MODEL: M-80

SERIAL NUMBERS AFFECTED: Below 2401

FUNCTION AFFECTED: Output and Power Supply Circuits

OUTPUT CIRCUIT AFTER MODIFICATION

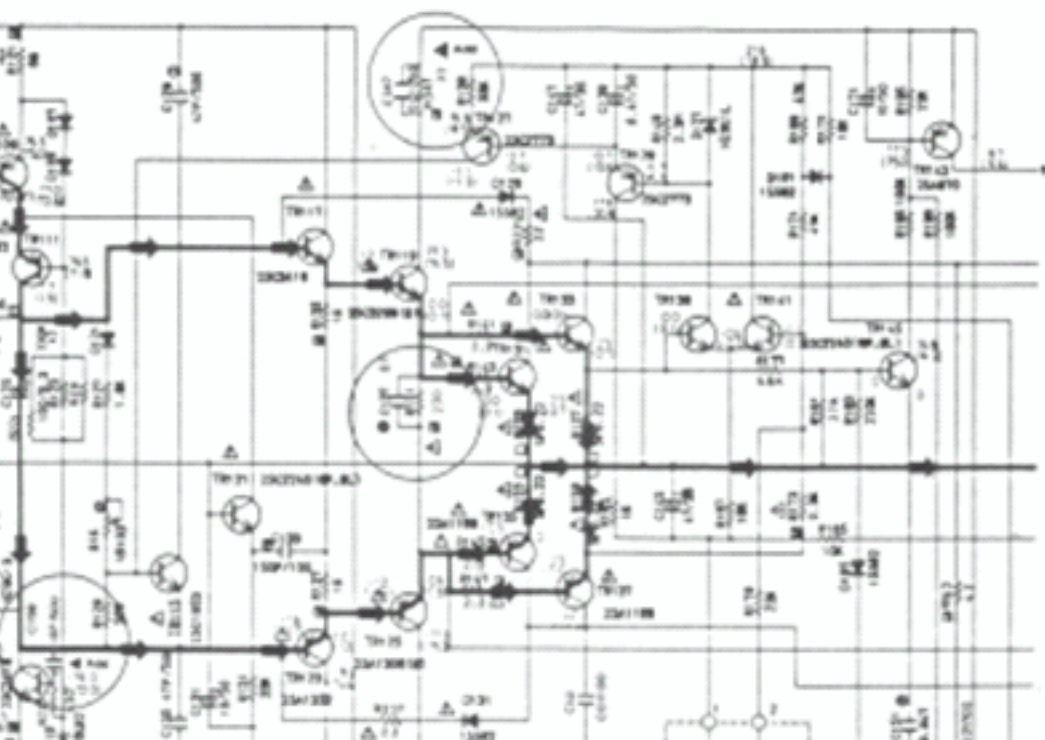
When the output circuit becomes shorted, the power consumption at TR119, TR120, TR125, and TR126 must be immediately reduced to minimize the number of damaged components.

Therefore, the parts for the M-80 circuits are changed as follows:

Ref. No.	Original Part	After Modification
R151/R152	100 ohm	220 ohm (HV455220)
C301-C304	.01mf/50v	.022 mf/50v (UA254220)
R347-R350	N/A	33 ohm (HV454330)
C347-C350	N/A	.01 mf/50v (UA254100)
C159-C160	N/A	18 pf/500v (FU351180)
